**Submission to the CNSC on
CNL's Draft Environmental
Impact Statement
Re: Nuclear Power
Demonstration Closure Project
(Ref No. 80121)**

February 13, 2018

Figure G-9. Release of Radionuclides from Reactor Vault to Boiler Room

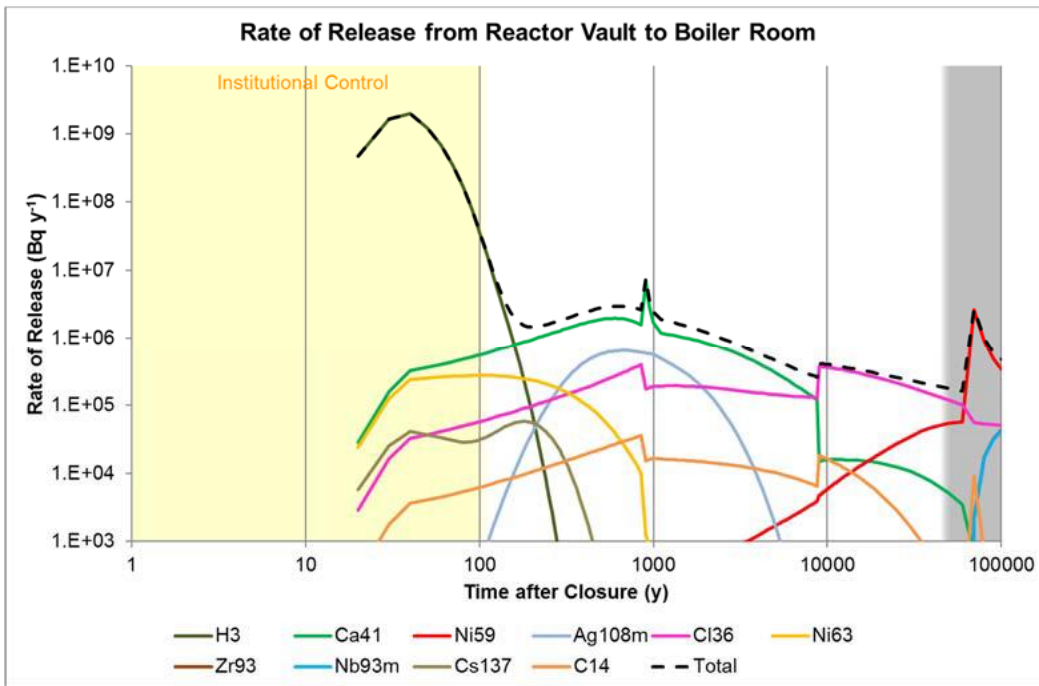
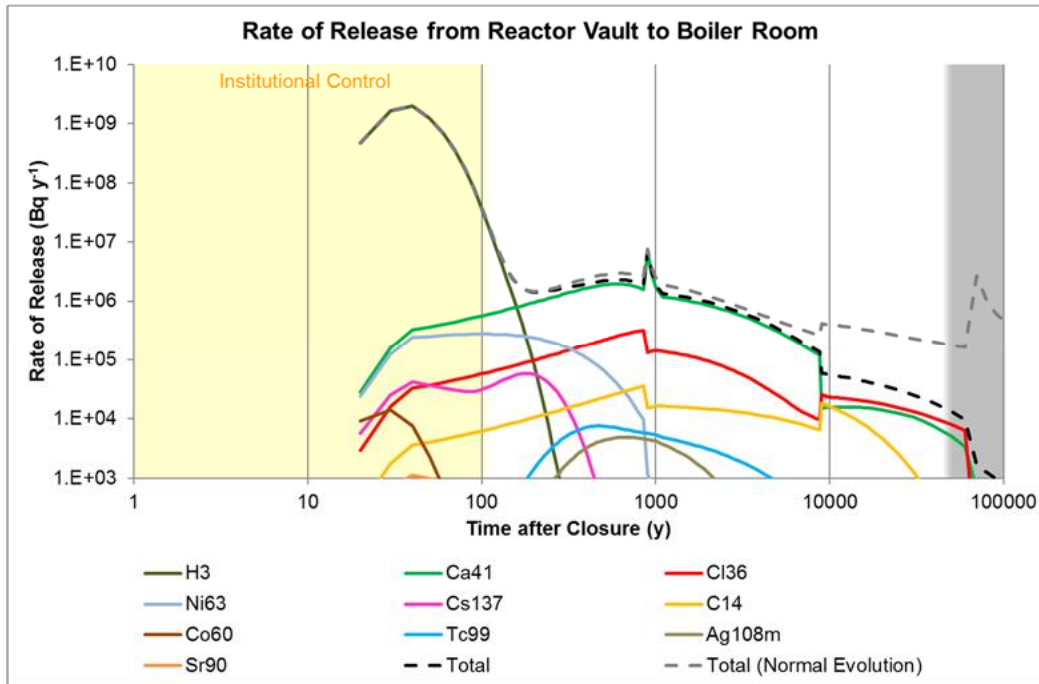
Since the publication of the draft EIS, however, CNL has indicated in its Post-Closure Safety Assessment report that the calandria may be removed before entombment and not form part of the waste inventory at the NPD site. It is uncertain whether CNL intends to remove the calandria immediately during decommissioning or defer its removal to a later date. The alternatives means analysis does not provide insight into which strategy might be preferable and it is unclear whether CNL has in fact undertaken any relative risk assessment on the matter.

While the removal of the calandria eliminates some long-lived nuclides (though not C-14 and tritium) there are few net savings as illustrated by Figures G-9 and G-70 reproduced below from Appendix G of the Post-Closure Safety Assessment report. While there may be little difference between rates of release (with the exception of some nuclides 800 to 1000 years post-closure), what these figures do not capture is a comparison of worker radioactive exposures and doses, the availability and options for off-site disposal, and intergenerational and future ecosystem impacts.

The concerns that must be weighed in determining whether the calandria should remain on site or be removed as soon as reasonably possible, include considerations such as:

- Based on the radiological inventory of the calandria, wouldn't worker dose level remain largely the same even after deferring the calandria's decommissioning?
- Would there be any capacity to decommission and remove the calandria in 100 to 300 years? Likewise, would the expertise, or funding exist?
- Regardless of the benefits of deferring, would removal of the calandria reduce the relative risk to the Ottawa river?
- A comparison of CNL's figures G9 and G70 in Appendix G of the Post-Closure Safety Assessment report indicate there is little difference between either strategy with respect to release of radionuclides, except for lower amounts of some nuclides 800 to 1000 years post-closure.
- While deferring removal would eliminate some long-lived radionuclides, would removal result in an overall benefit?
- What are the costs associated for each strategy?

has not provided an objective evidence-based analysis of available options. CNL should weigh the various advantages and disadvantages of the alternative means against each other for the specific circumstances of the NPDWF site, provide a coherent explanation of the risks posed to the environmental components by each of the strategies, and provide a rationally based explanation as to why a specific strategy is preferred.
